## **EQUIPMENT INVOLVED:**

Ovens with FastPad touch screen (FM2010).

## **WHAT'S NEW:**

A new update of the FastPad touch screen is available (version: **IHM: 035 – UC: 046 – FLA: 018 – REL: 133**). This version is installed on production line from serial n°: P27519506H (19/03/2013). It is possible to install it on all FastPad ovens via the USB stick after having downloaded it from our network using the “procédure mise à jour de l’interface FastPad EN-FR” procedure.

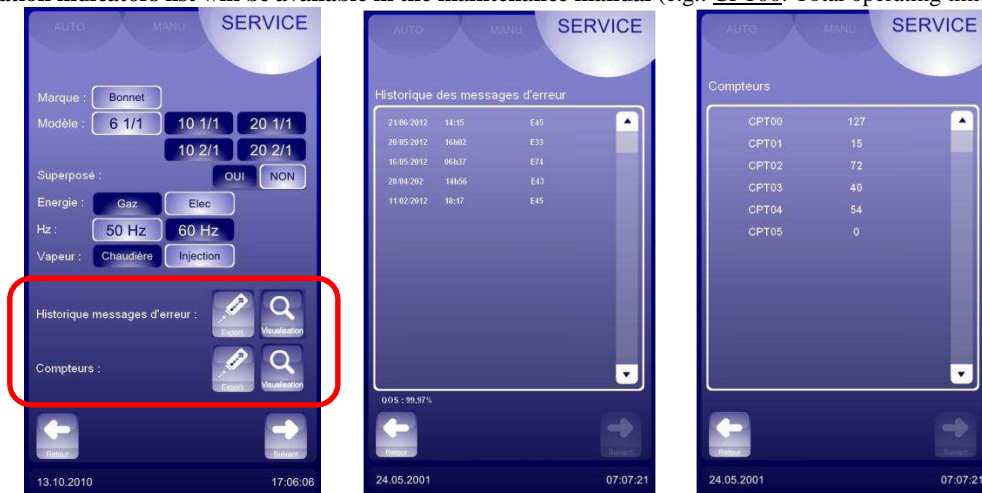
The new FastPad touch screen update includes :

- ✓ **modification of error messages titles and management**
- ✓ **addition of an error messages history** (visualization on the oven + exportation possible on USB stick)
- ✓ **addition of time operation indicators** (visualization on the oven + exportation possible on USB stick)
- ✓ addition of the Russian language
- ✓ addition of user manual in Portuguese and German
- ✓ correction of temperature setting in “descaling only” mode (cleaning mode)
- ✓ correction of rinsing launching in “auto cleaning” mode
- ✓ correction of day shifting in « Auto cleaning » mode (in English).
